ADDENDUM NO. 3

CAJON HIGH SCHOOL - THEATER RENOVATION

DSA No. 04-114799 File No. 36-H7

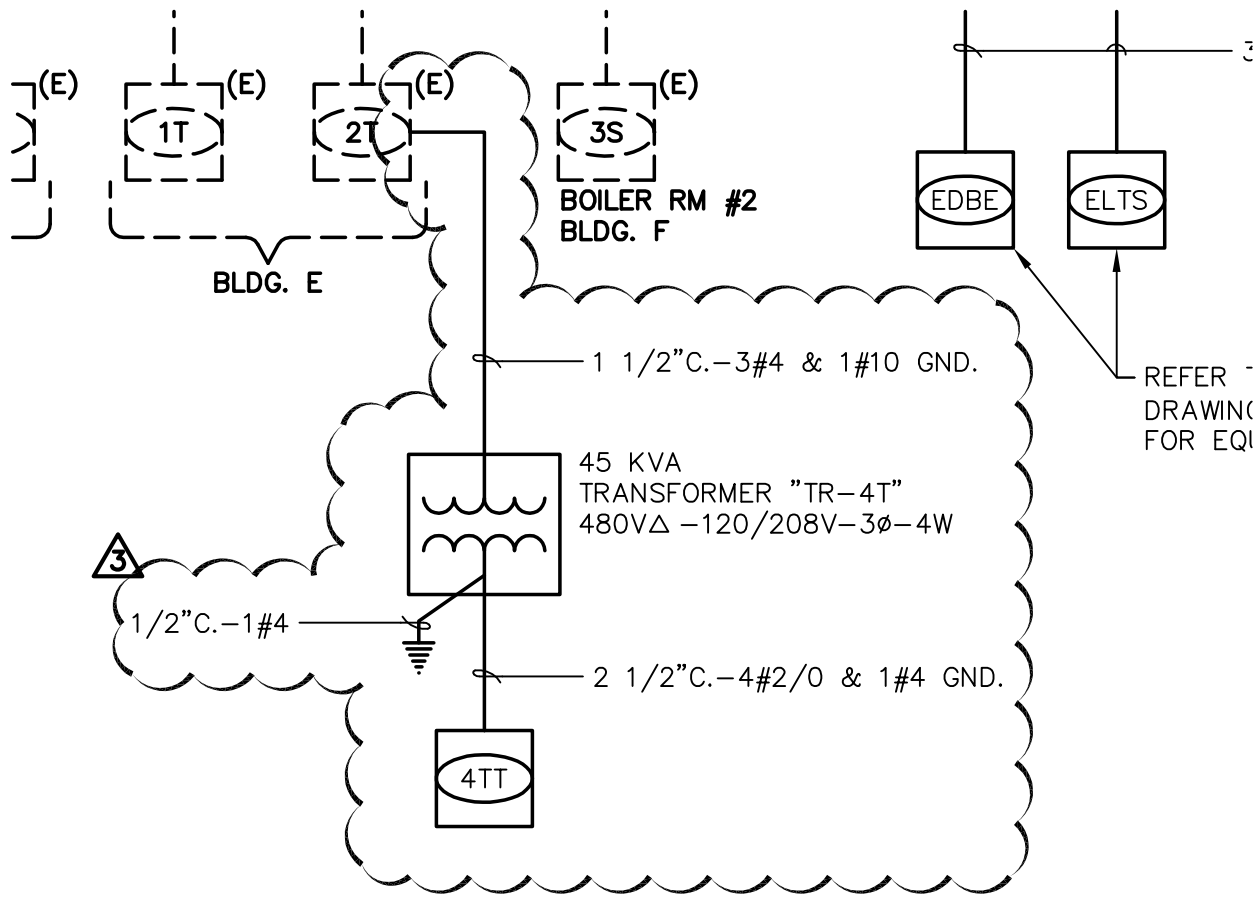
- Item No. 3.6 Reference Sheet E-0.3:
 3.6.1 Revise Fixture P/3 per attached Sketch ESK-3.1.
- Item No. 3.7 Reference Sheet E-0.4:
 3.7.1 Add transformer at Bldg E single line diagram per attached Sketch ESK-3.2.
- Item No. 3.8 Reference Sheet E-1.1:
 3.8.1 Revise site plan per attached Sketch ESK-3.3.
- Item No. 3.9 Reference Sheet E-2.0:
 3.9.1 Revise Sheet Notes 5 through 9 per attached Sketch ESK-3.4.
- Item No. 3.10 Reference Sheet E-2.1:
 3.10.1 Revise sheet per clouded areas of attached revised Sheet E-2.1.
- Item No. 3.11 Reference Sheet E-2.2:
 3.11.1 Revise sheet per clouded areas of attached revised Sheet E-2.2.
- Item No. 3.12 Reference Sheet E-5.1:
 3.12.1 Revise sheet per clouded areas of attached revised Sheet E-5.1.
- Item No. 3.13 Reference New Audio/Video Plans:
 3.13.1 Add attached Sketches AV1, AV2, AV3 and AV4 indicating the audio/video plans.
